**Eugene School District 4J
ROOSEVELT MIDDLE SCHOOL**
680 East 24th Avenue
Eugene, OR 97405
CIP No. 410.566.001

ADDENDUM NO. 6

This Addendum forms a part of the Contract Documents and modifies the original Bidding Documents dated February 18, 2015 and subsequent addenda as noted below. Acknowledge receipt of this Addendum in the space provided on the Bid Form. Failure to do so may subject the Bidder to disqualification.

A1 FIRST FLOOR UNDERGROUND - ZONE D - PLUMBING
1/8" = 1'-0"

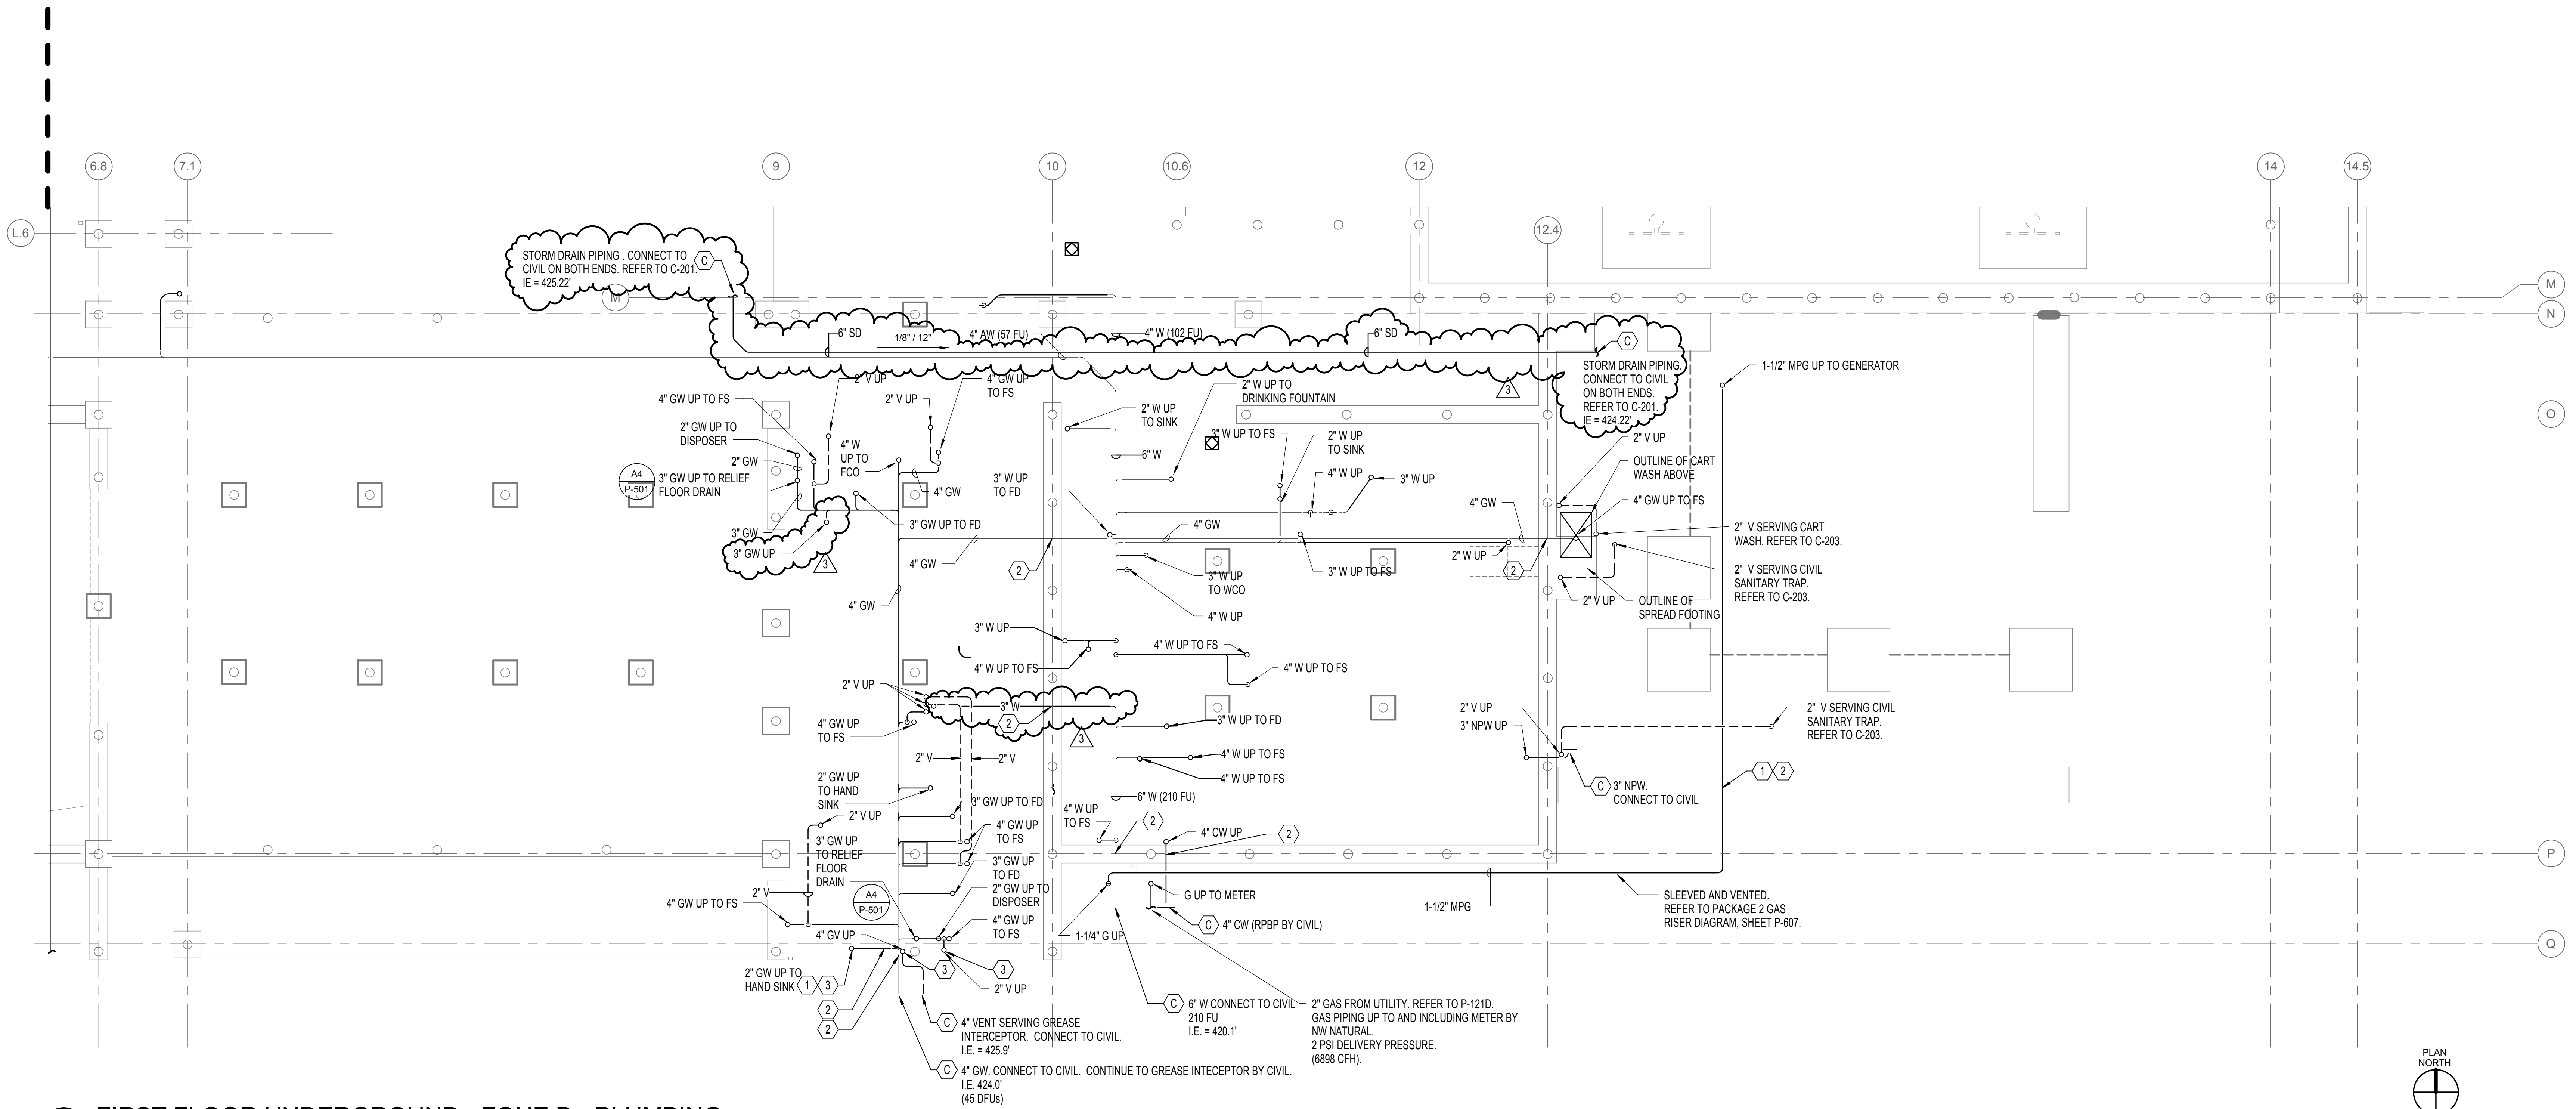
- A. Replace Sheet with revised Sheet P-120D: Add below grade stormwater piping, which connects to Civil on both sides of the building. Note this piping was previously shown on Civil plans.

UNDERGROUND OVERALL - ELECTRICAL

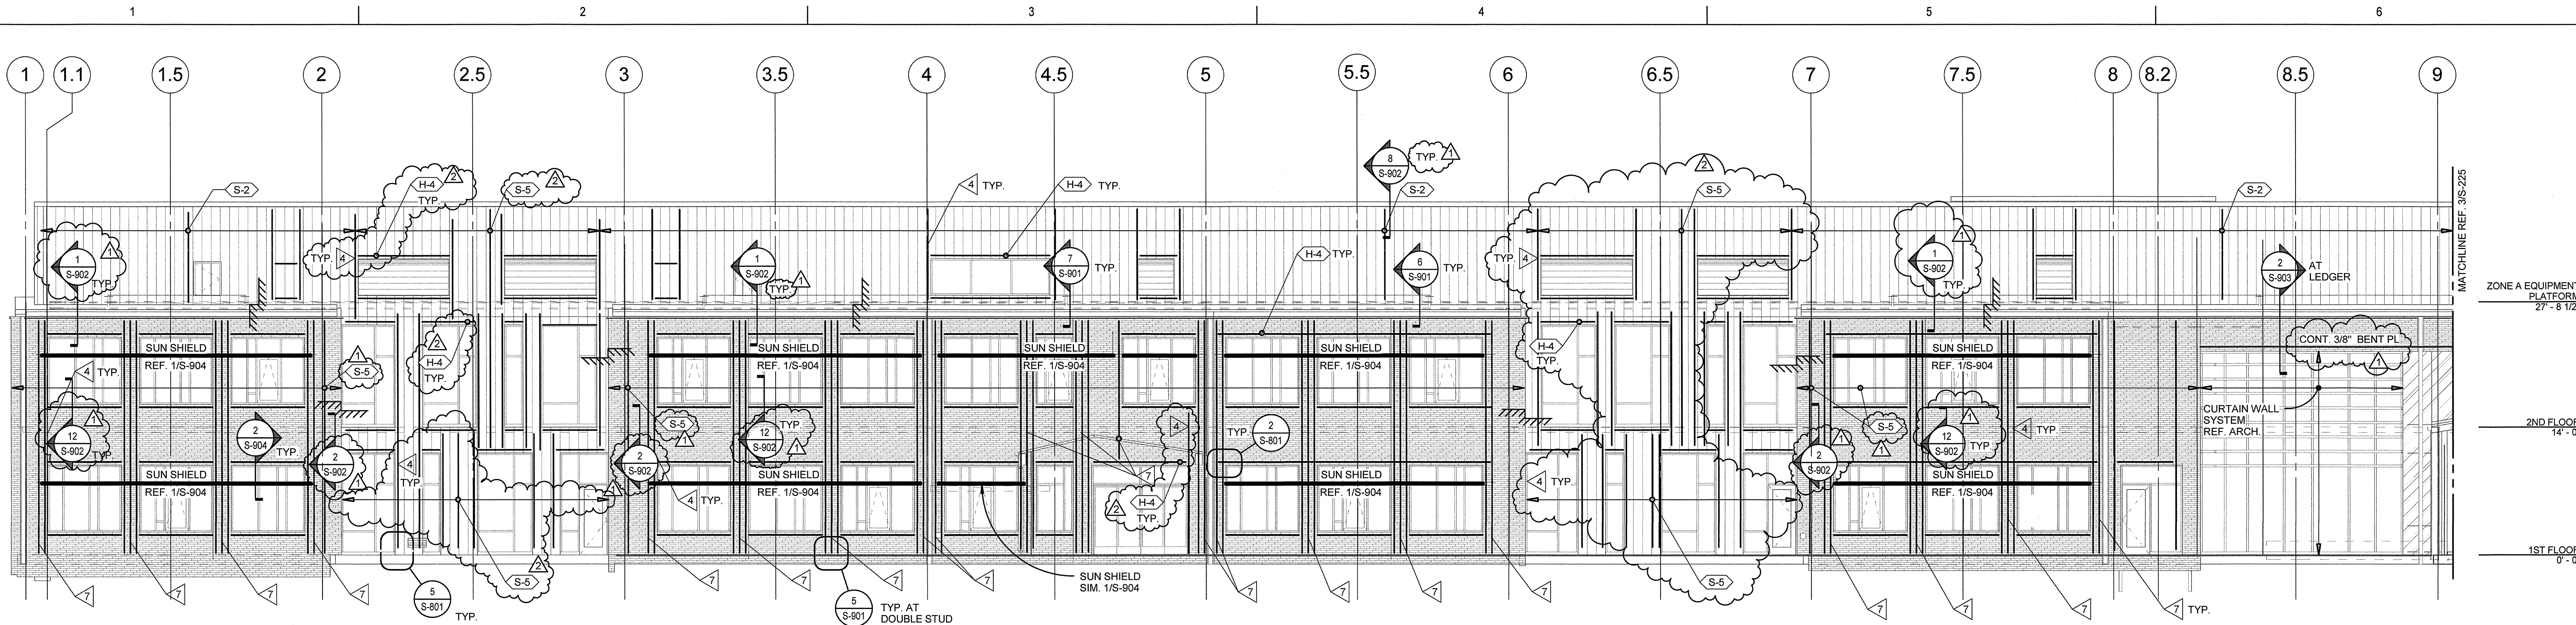
- A. Replace Sheet with revised Sheet E-110: Relocate electrical panels at Kitchen

A1 ROOF PLAN
 1/16" = 1'-0"

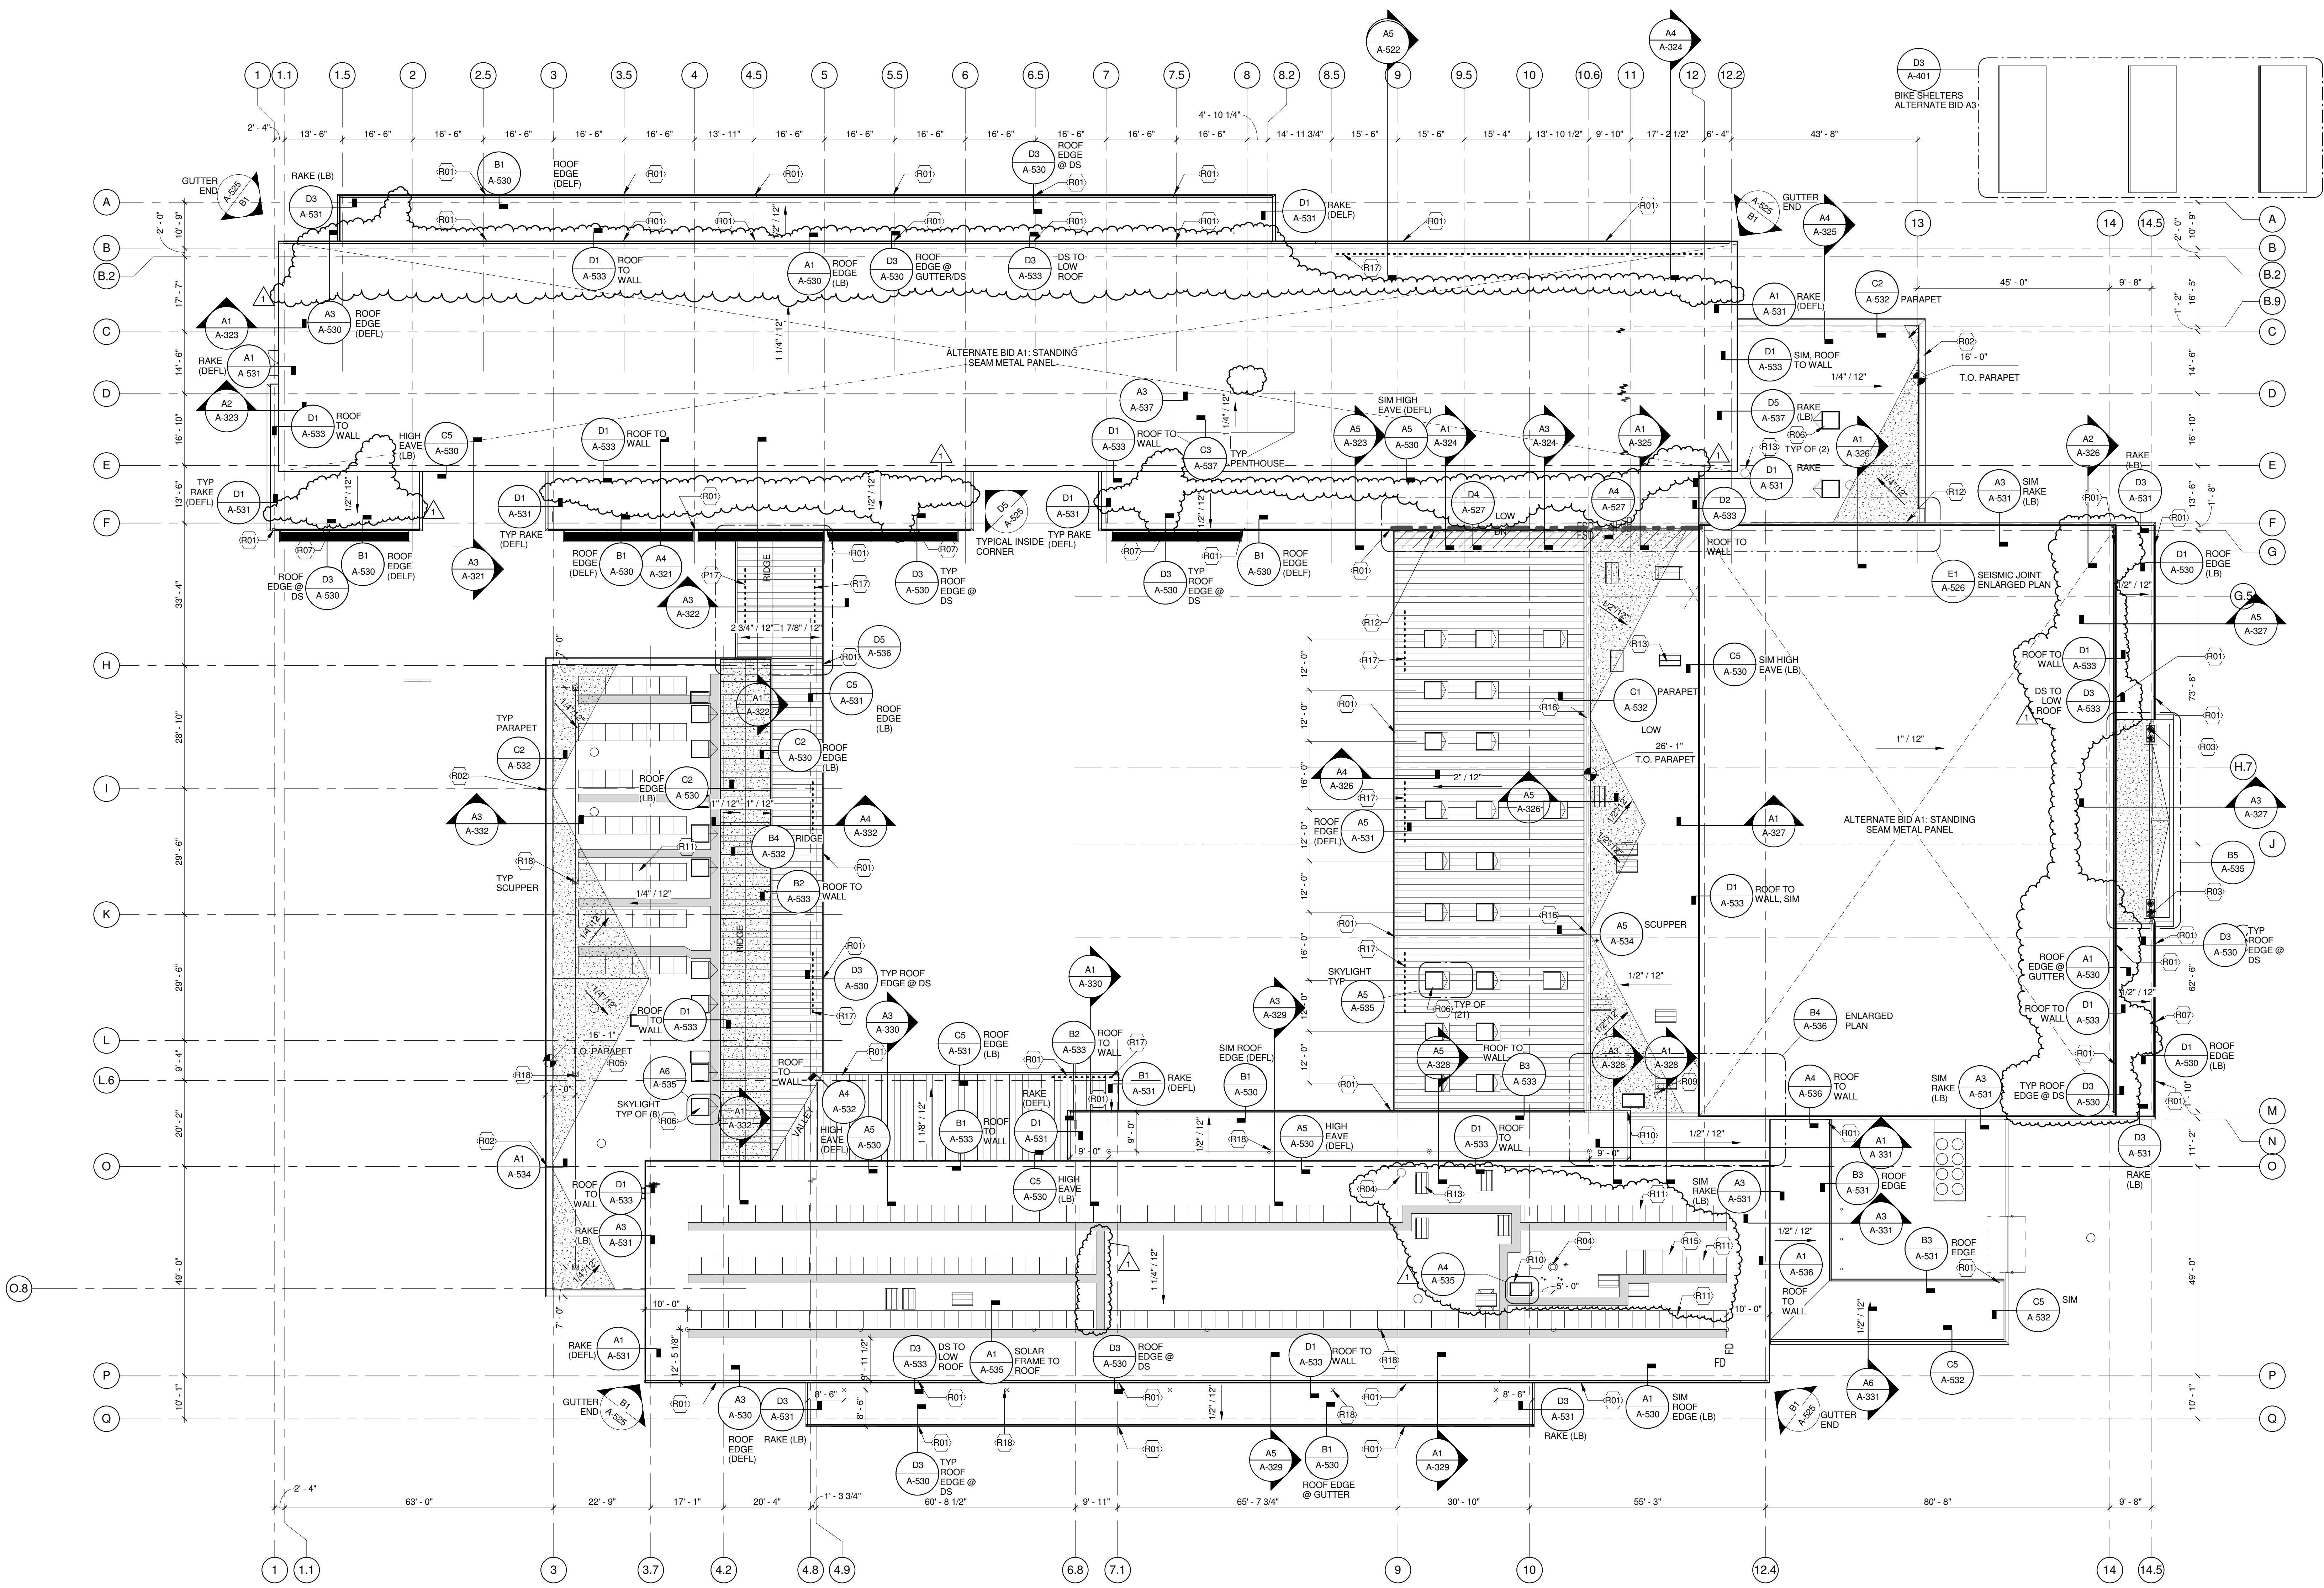
- A. Replace Sheet with attached revised Sheet A-141. Clarification: The fall protection anchors are removed from roofs at Zones A, B, and C. The layout of roof equipment in Zone D was revised.
